ARCHITECTS FURTHER INFORMATION RESPONSE

for PROPOSED RESIDENTIAL DEVELOPMENT
CLONBURRIS STRATEGIC DEVELOPMENT ZONE
PHASE T3

Further Information Submission
April 2023

IMAGE 2 – NET DEVELOPMENT AREAS AND DENSITIES

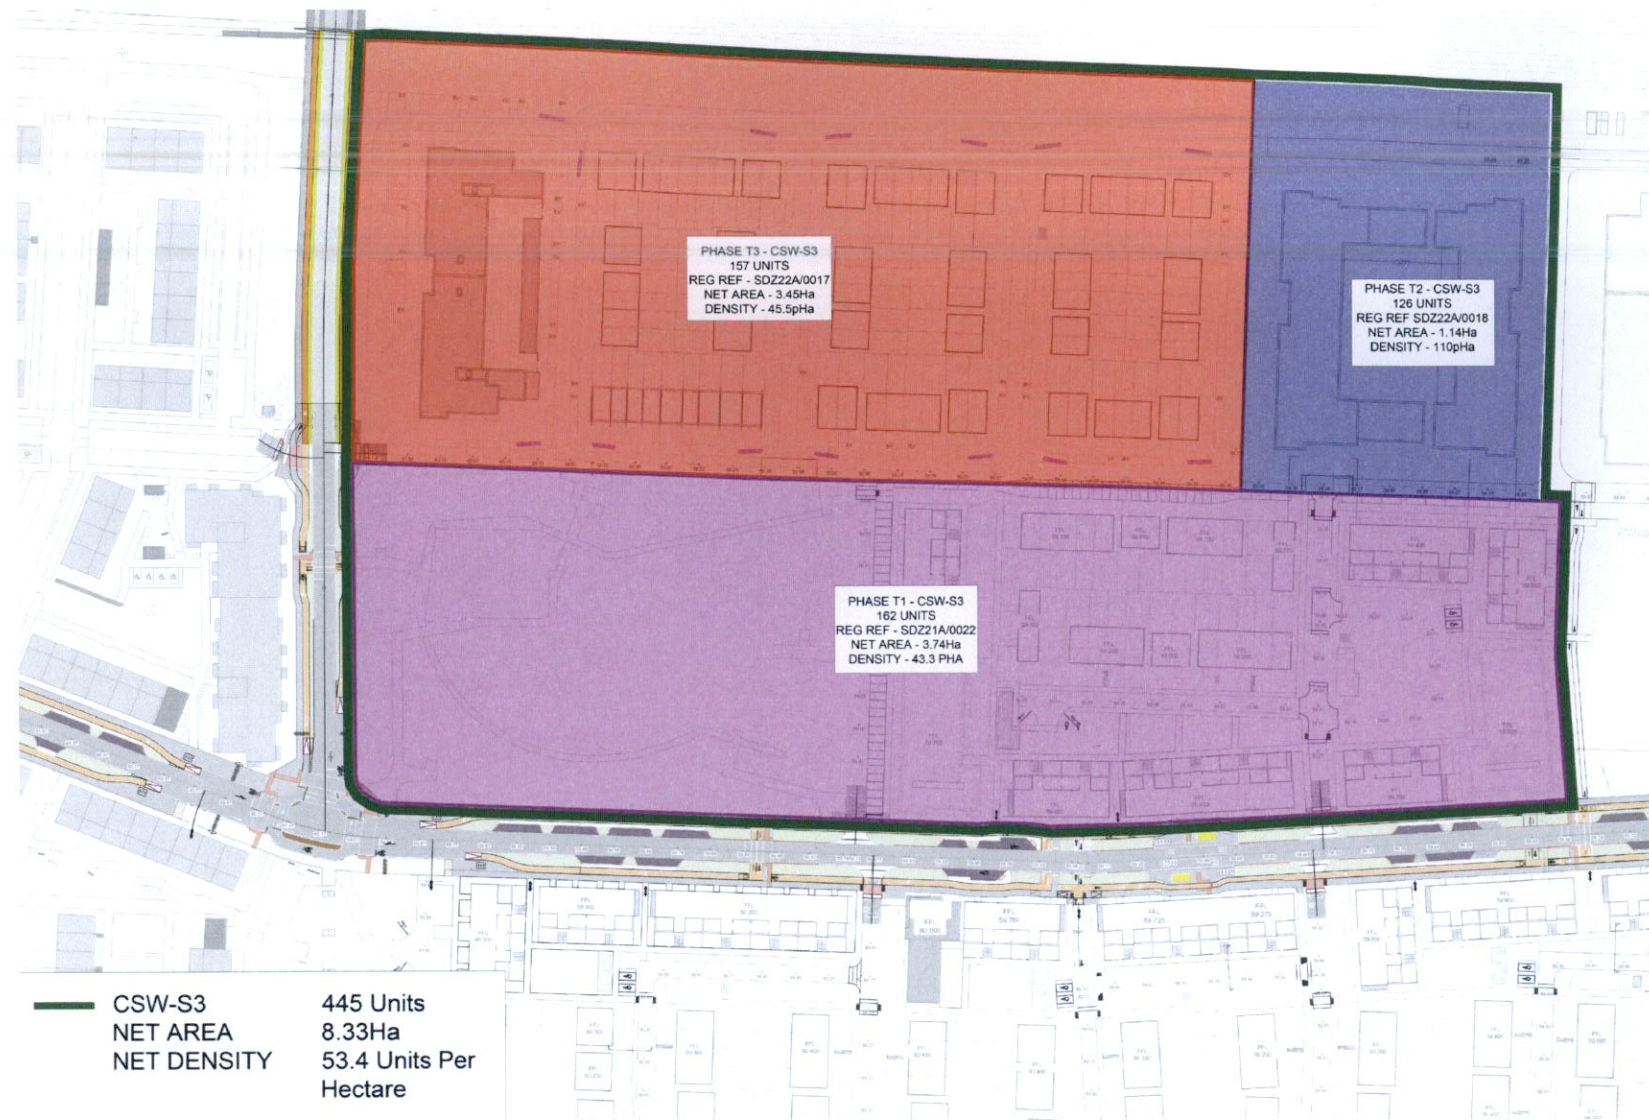
(c) It is unclear how the applicant has arrived at this density calculation. The applicant is requested to set out the net density for

- the current application - Net Density for Phase T3 (SDZ22A/0017) is 45.5 pHa
- the current application and previously approved scheme - Net Density for the previously approved section of CSW-S3 (SDZ21A/0022) and T3 is 44.36 pHa
- the current application, previously approved scheme and units proposed under SDZ22A/0018 - Net Density for all 3 sections of CSW-S3 is 53.4 pHa.

These 3 areas total 8.33 hectares and propose 445 units, meaning a sector density of 53.4 units per hectare for CSW-S3.

IMAGE 3 – NORTH FACING APARTMENT

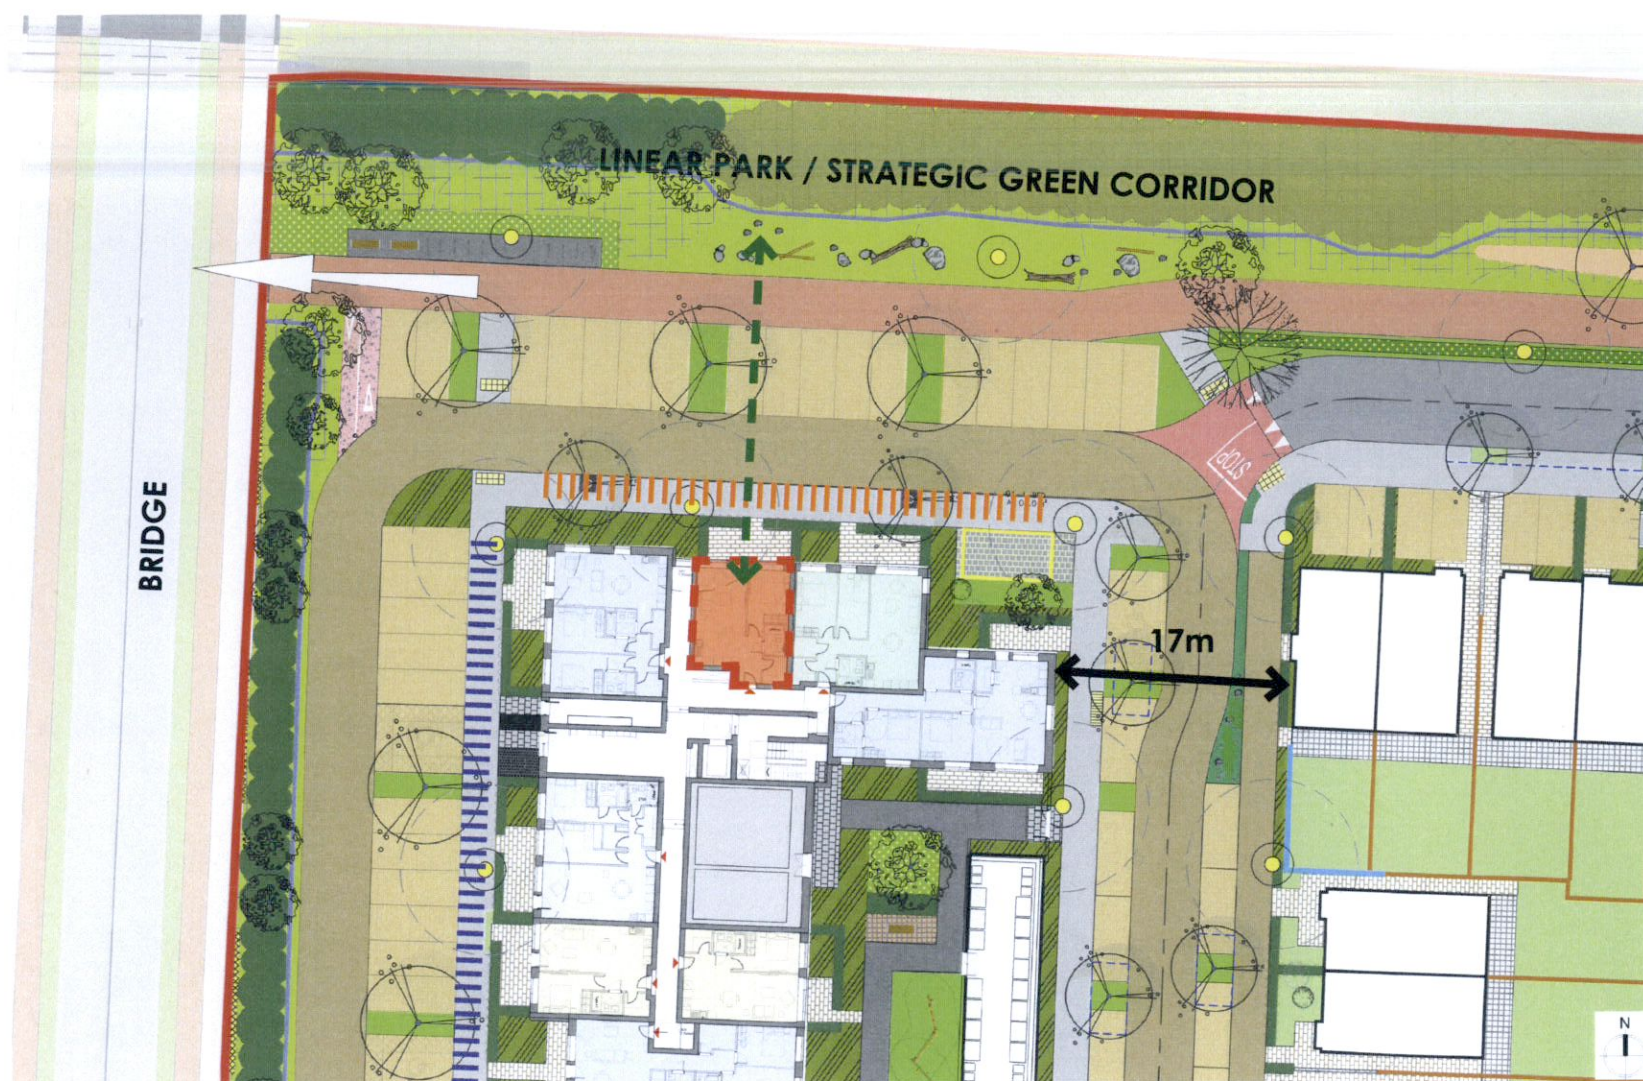
(c) The applicant is requested to set out how many apartments are single aspect (north). A clear justification and rationale should be provided for any single aspect north facing apartments

4 no. single aspect north facing units have been proposed. These units are 1 bed, and have been proposed to fullfill planning scheme requirements which call for Avenue and Rail Frontage in this location. This requirement led us to propose a robust and defined building edge to the bridge at 4 storeys, which was extended around to the north elevation, closing out the development cell and narrowing the street to the east of the apartment block into compliance with "intimate local street" widths set out in the planning scheme.

Additionally, the Ground floor units are "Own door access" and enjoy generous terrace areas. The upper floors are overlooking a substantial Green Amenity space as the Local Green Corridor runs parallel to these units. We would view this as a significant visual amenity in the locality. All 4 north facing single aspect units are in compliance with BRE 2nd and 3rd Edition guidelines relating to daylight provision.

IMAGE 4 – BICYCLE STORAGE LOCATIONS

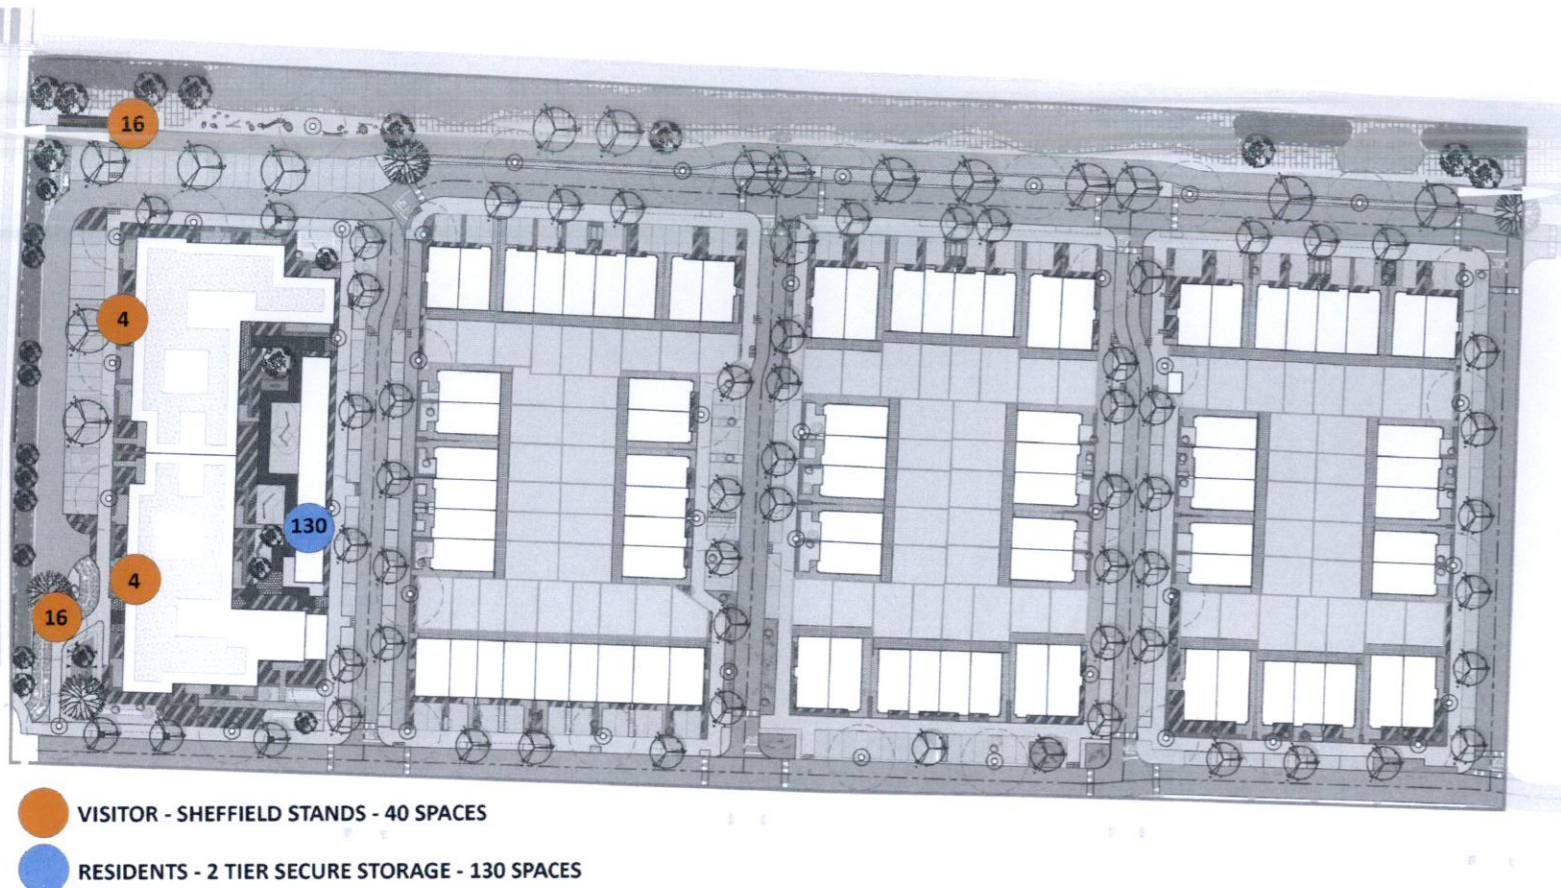
V. gives detail re the bicycle stand specification (i.e. Sheffield stands) proposed.

The 170 spaces proposed as part of this application are provided in a mix of typologies and locations. For the apartment residents 130 spaces are provided in the secure storage facility in the courtyard of the apartment block. The courtyard is secure, can be accessed directly from the street and also has direct access points to both circulation cores. This will facilitate the convenient access from street to apartment unit, via the courtyard which contains the secure storage. A 2 tier secure storage system is proposed to facilitate the 130 spaces. For example specification for the 2 tier bike system and additional details on bicycle storage, please refer to PL010 Bin and Bike Stores Rev A which has been submitted as part of this FI request.

Sheffield stands provide a further 40 spaces for the use of visitors and are integrated in the landscaping proposals. Locations and specifications of the bicycle stands are as per Image 4 (left).
